# MEETING AGENDA

## Appearance Commission

A. **Public Meeting** for Case 26-17: Appearance Review for Metra TPSS/Substation Facility at 18277 Park Avenue

B. **Public Meeting** for Case 26-34: Appearance Review for 7Brew Drive-Thru Coffee at 17855 Halsted Street

# SITE PLAN | COMED

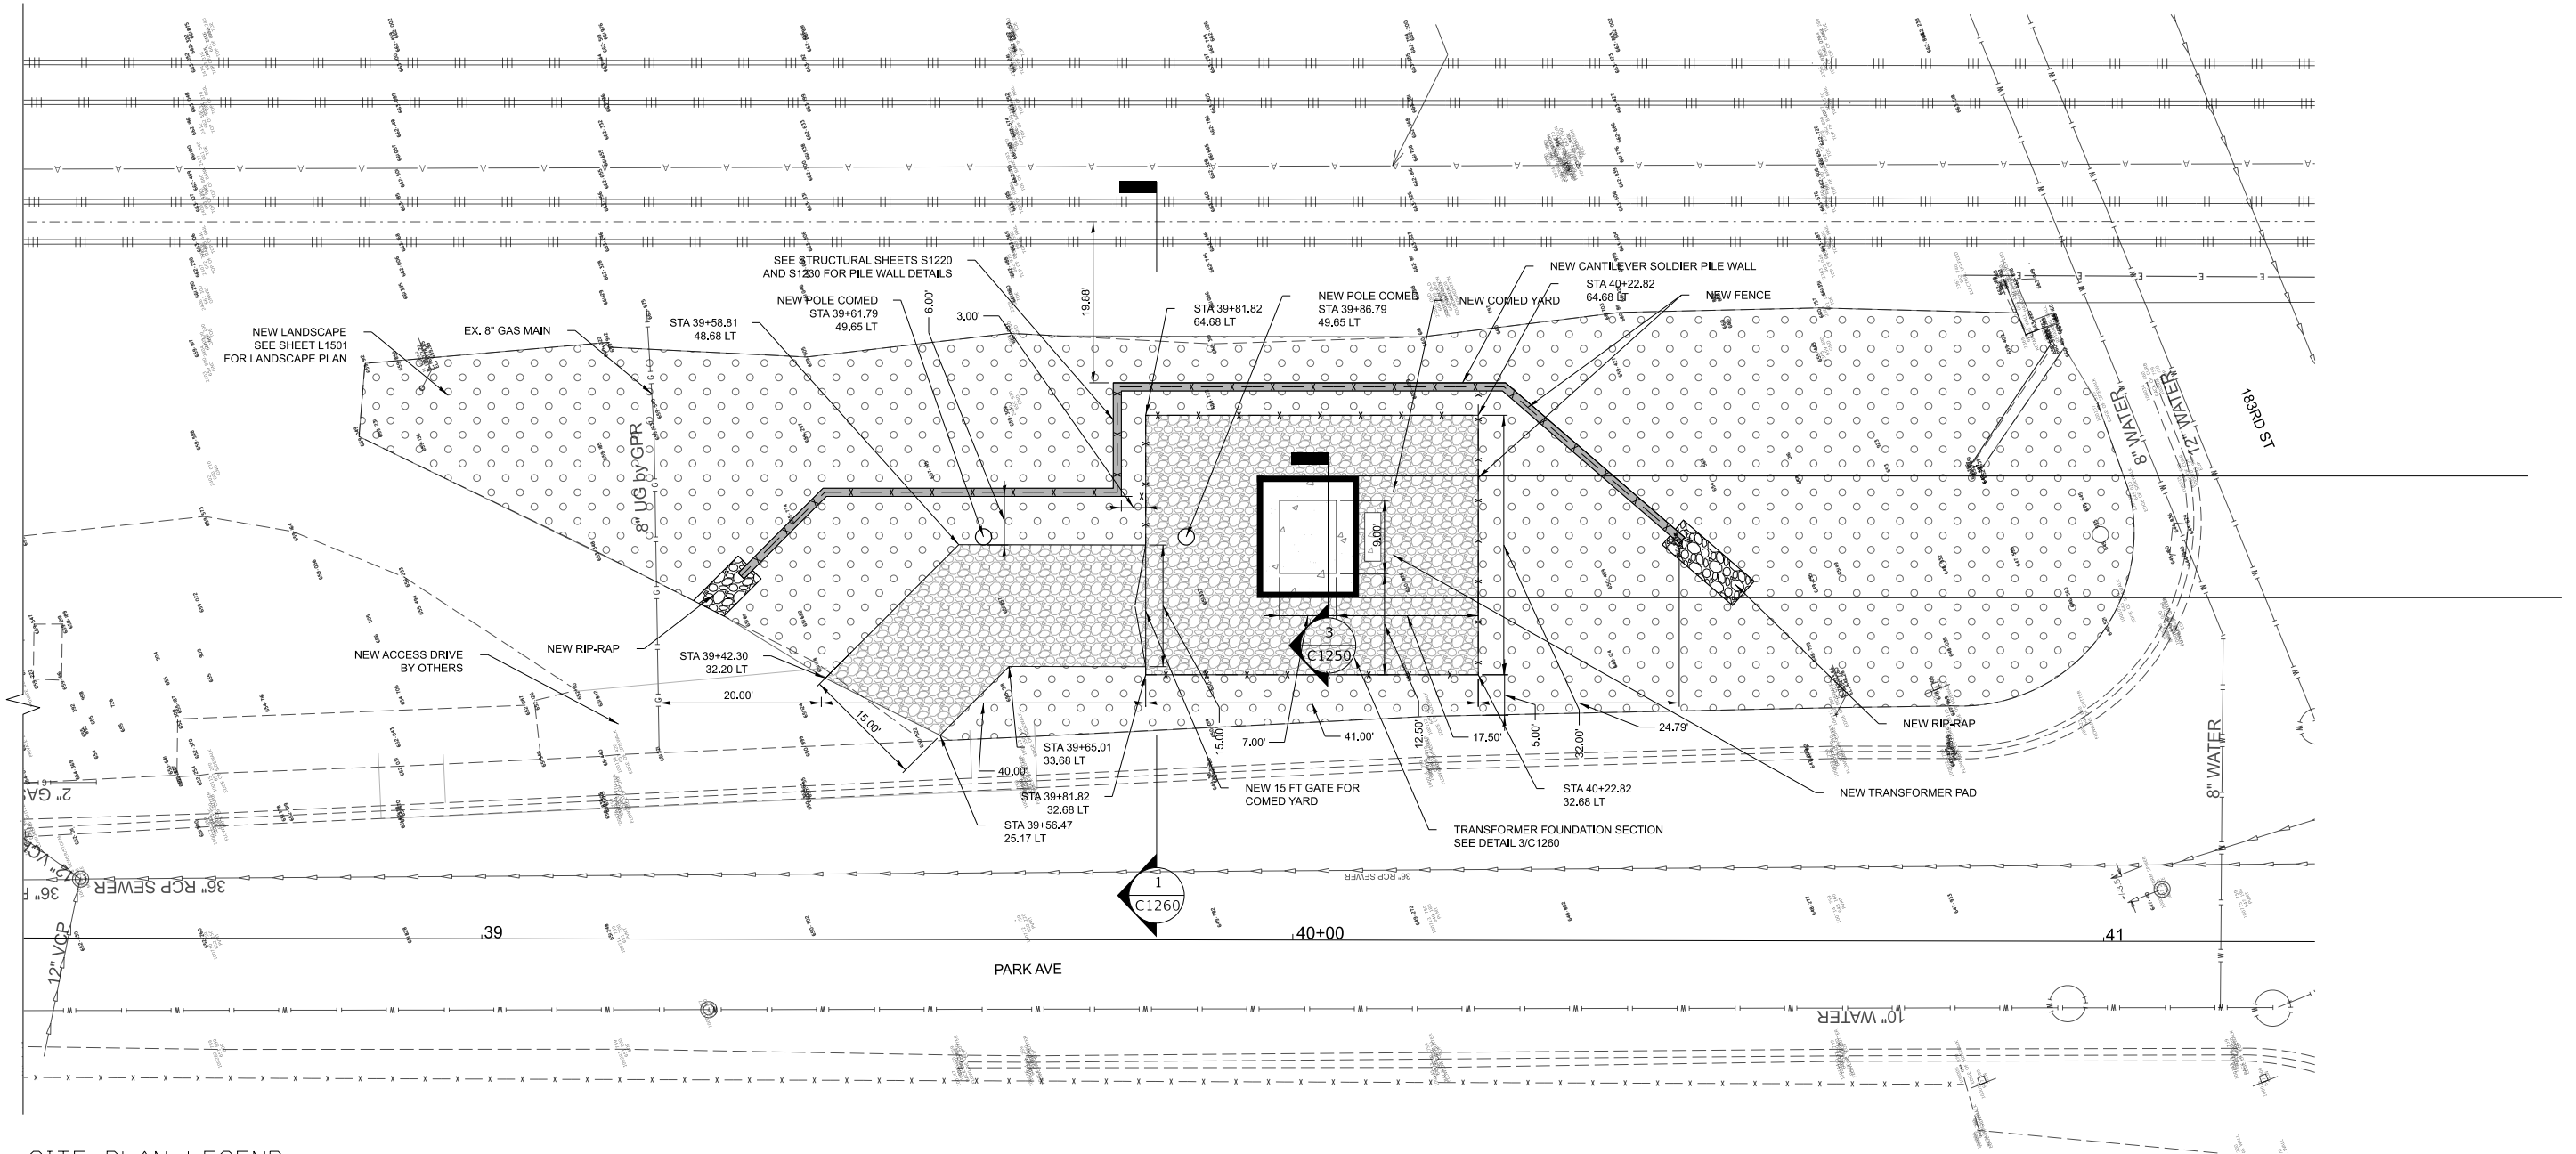
The outdoor transformer yard will include a large electrical transformer box surrounded by a 1,500 square-foot outdoor fenced yard area. The yard will be a gravel yard with room sufficient to temporarily provide parking for service vehicles. The yard area will be accessible to vehicles through a large gate. The yard will be landscaped to screen the yard from 183<sup>rd</sup> Street and Park Avenue.

The existing abandoned control tower owned by the Canadian National Railroad will not be removed. There are no current plans for renovating or improving the tower by Canadian National. The area between the existing gravel access driveway and the Canadian National control tower is controlled by Canadian National and is not included in plans for this proposed facility.

No lighting plans have been submitted for the outdoor transformer yard on the south side of the facility. Staff have provided a recommended condition of approval to include security lighting around the outdoor transformer yard for protection from vandalism and other security concerns. The Planning and Zoning Commission conditioned approval of the Site Plan Review for this project on the submittal of a photometric plan indicating the location of security lighting fixtures and their impact on surrounding property. **This condition has been included in the recommended motion for this case (see *Recommended Appearance Commission Action*).**

1. Submit a revised landscape plan with building permit submittals providing an alternative groundcover species selection for the proposed juniper bushes located in the southern portion of the property;
2. Submit a photometric plan with building permit submittals demonstrating the location and lighting impact of security lighting fixtures installed at the transformer yard on the southern half of the property;
3. Director of economic and community development shall provide a waiver of the transparency requirements for the building as permitted in Section 44-05-11.(d) of the Village Zoning Ordinance.

# SITE PLAN | COMED LANDSCAPE PLAN

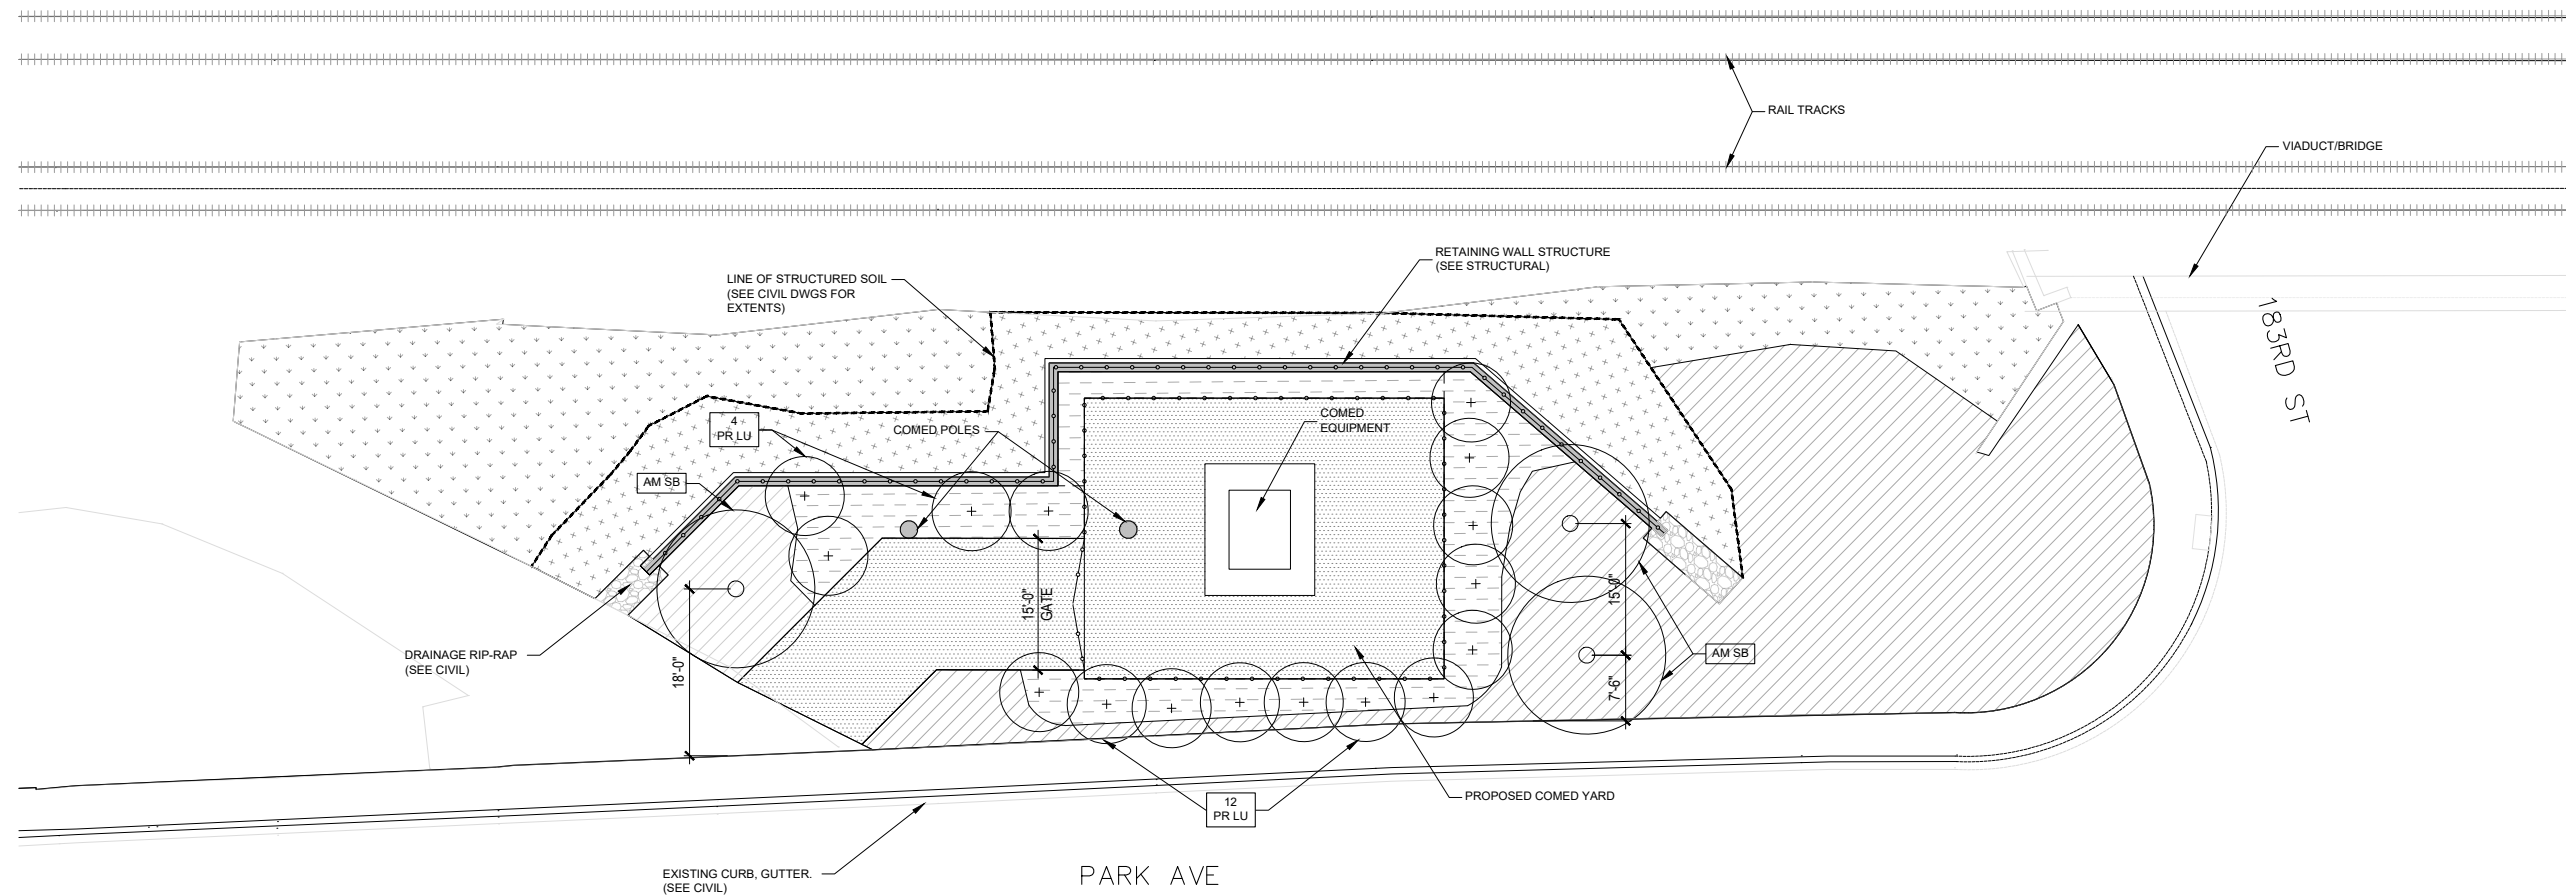
The remainder of the site south of the outdoor transformer yard will be covered in mulch and groundcover. The applicant has proposed to use juniper bushes planted in mulch to provide this groundcover, which will improve the aesthetics of the site and provide additional absorption of groundwater. **The Village Arborist has recommended an alternative species to replace the juniper bushes, and this replacement has been provided as a recommended condition with this approval (see Recommended Appearance Commission Action).**

# LIGHTING PLAN

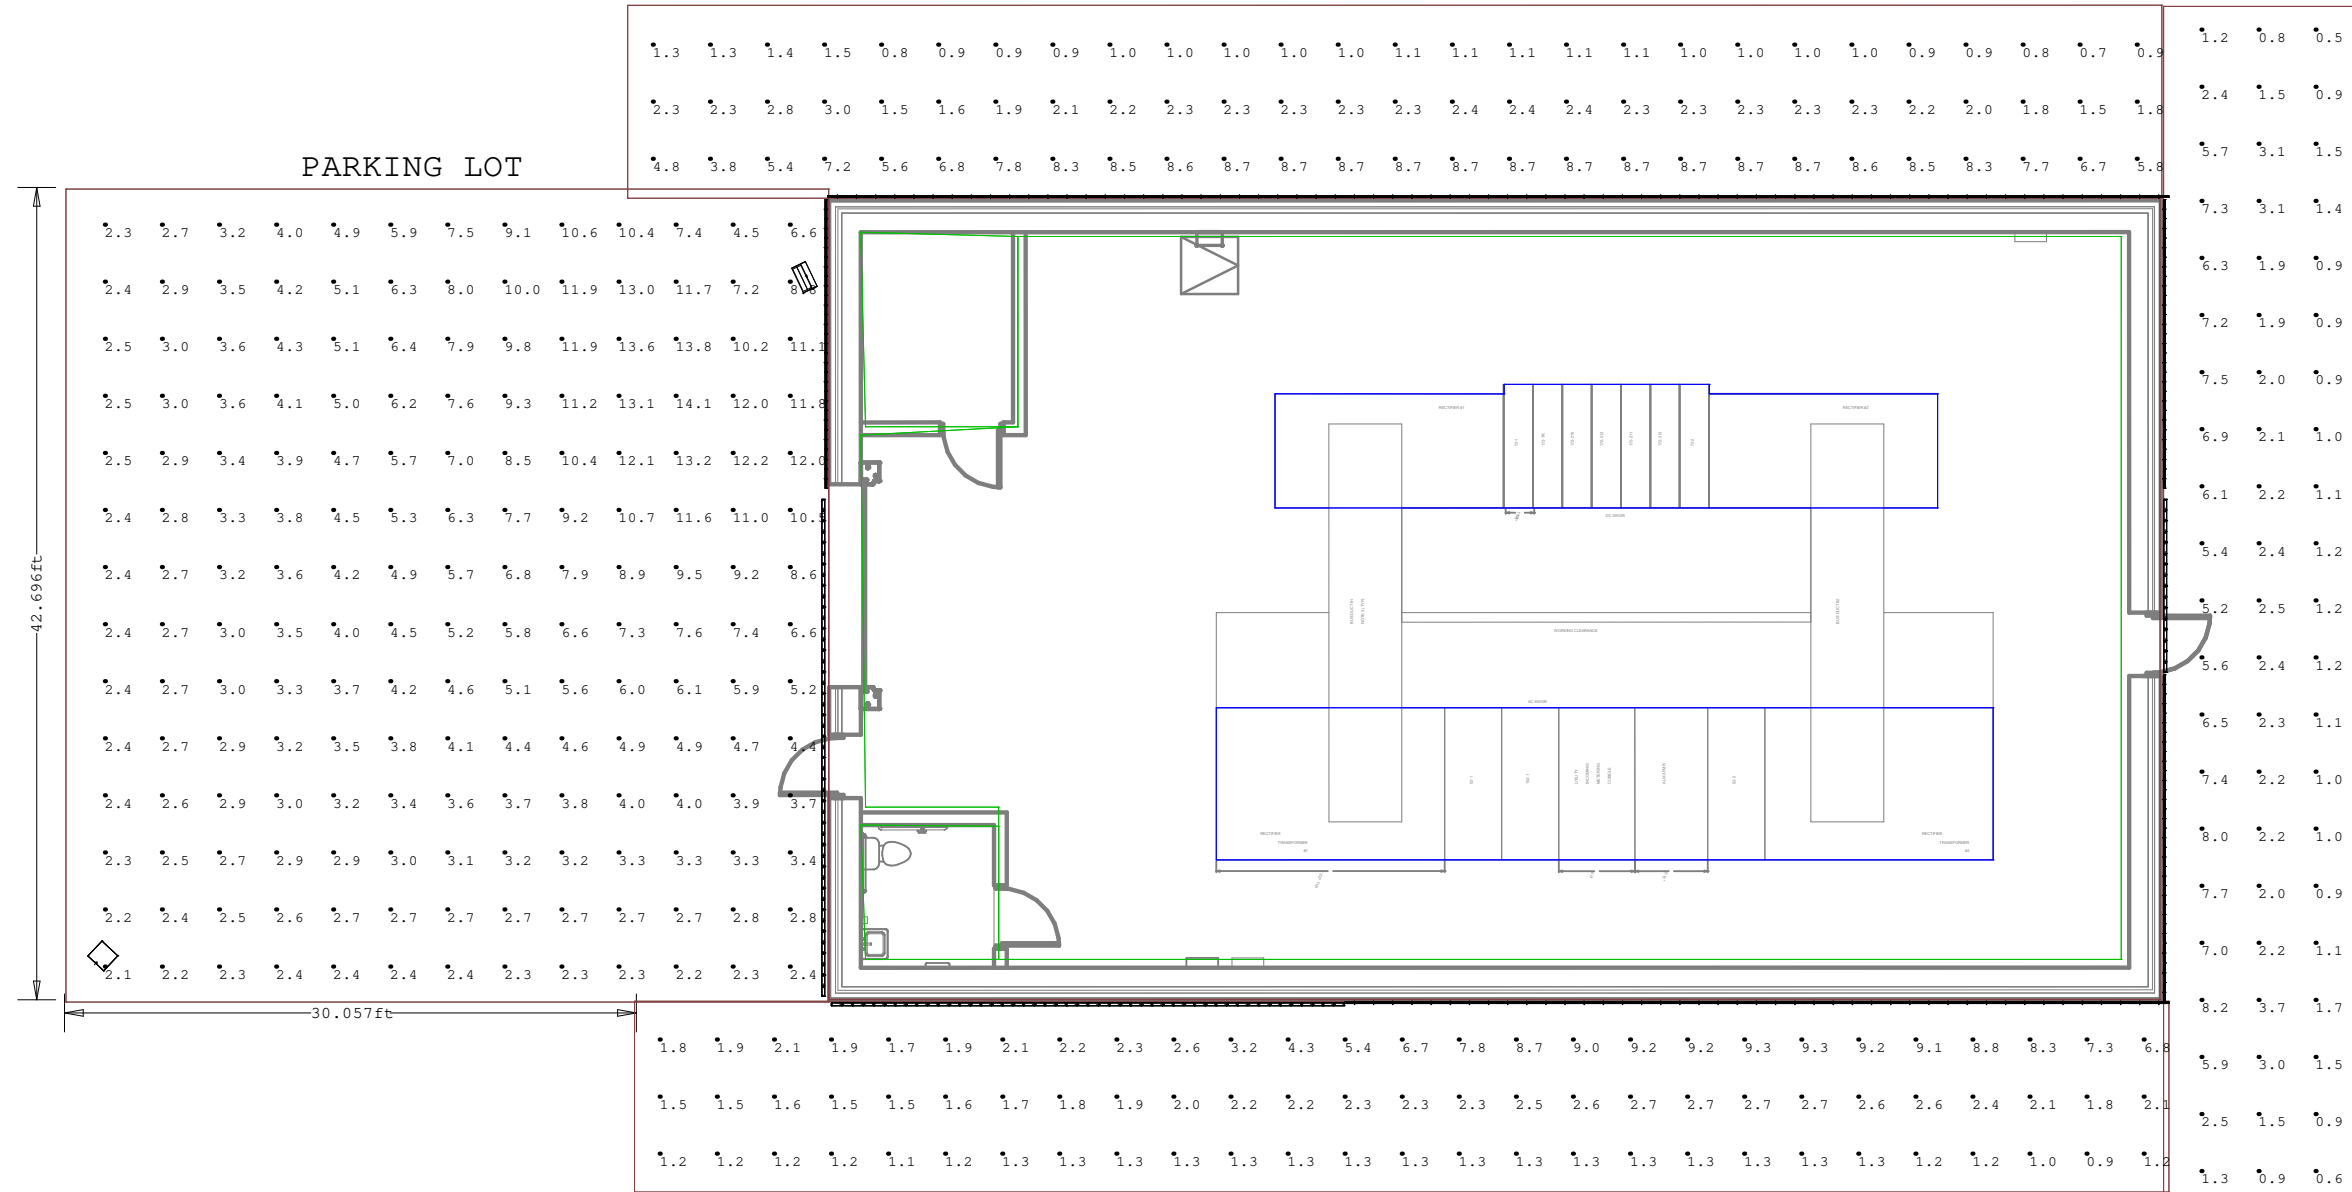
Security lighting fixtures are proposed to be installed on the northeast corner of the traction power substation building to provide lighting for the fenced yard adjacent to the building. The LED light bands on all four elevations of the building will also provide additional lighting around the perimeter of the substation building and on the public sidewalk along Park Avenue.

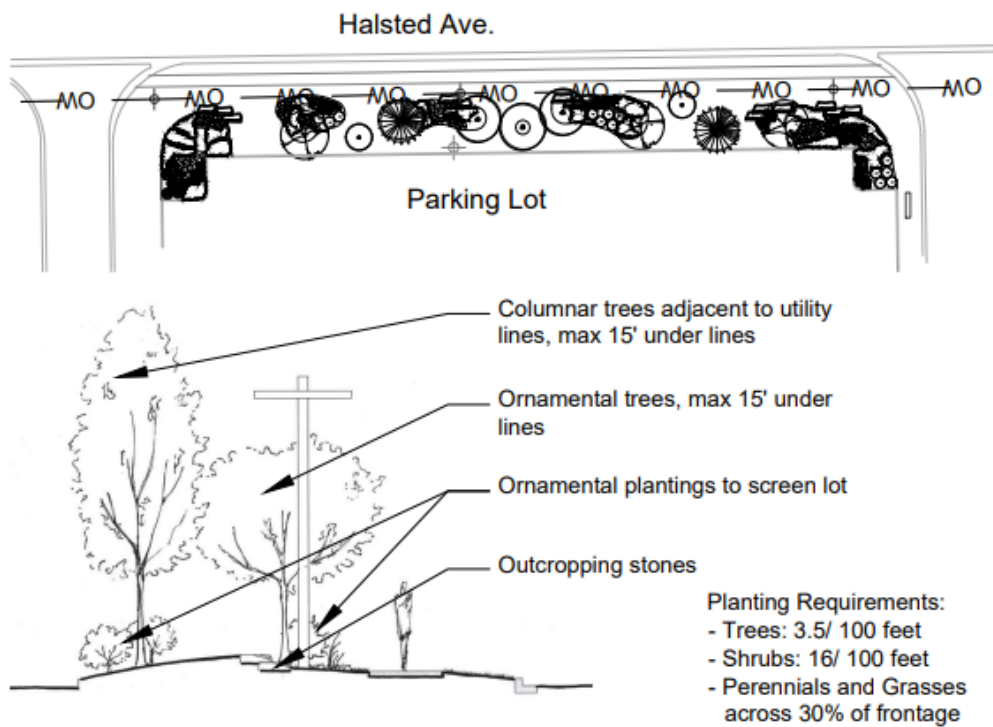
The applicant is required to provide a minimum 15' wide landscape area along Halsted Street as a parking lot perimeter landscape area. This area shall be located between parking spaces and the property line adjacent to the right-of-way of Halsted Street. This landscape area shall meet the following requirements:

- For every three feet, one shrub or native grass shall be provided – **not met**
- For every 25' of landscape area length, one understory/evergreen tree shall be provided – **not met**

- For every 25' of landscape area length, one canopy tree shall be provided – **met, 14 trees required, 16 trees provided.**
- The remainder of landscaped area outside of shrubs/plantings shall be planted with live groundcover – **met**

The applicant has also provided a perimeter landscaping area which is narrower than the required width for the landscaping area (12' vs. 15'). The applicant has submitted a variance for this reduction in required width, which will be reviewed by the Planning and Zoning Commission at a future meeting.

**Staff has recommended a condition of approval to require the addition of shrubs/native grasses and understory/evergreen trees to meet the recommendations of the Halsted Street Corridor Landscape Plan. See Recommended Appearance Commission Action.**

1. Submit a revised landscape plan to provide shrubs/grasses and understory/evergreen trees as required by the Village Zoning Ordinance and the Halsted Street Corridor Landscape Plan, subject to review by Village planning staff and Village Arborist;
2. Director of economic and community development shall provide a waiver of the transparency requirements for the building as permitted in Section 44-05-11.(d) of the Village Zoning Ordinance;
3. Applicant shall receive a variance from Tier I material standards set forth in Section 44-05-11 of the Village Zoning Ordinance.
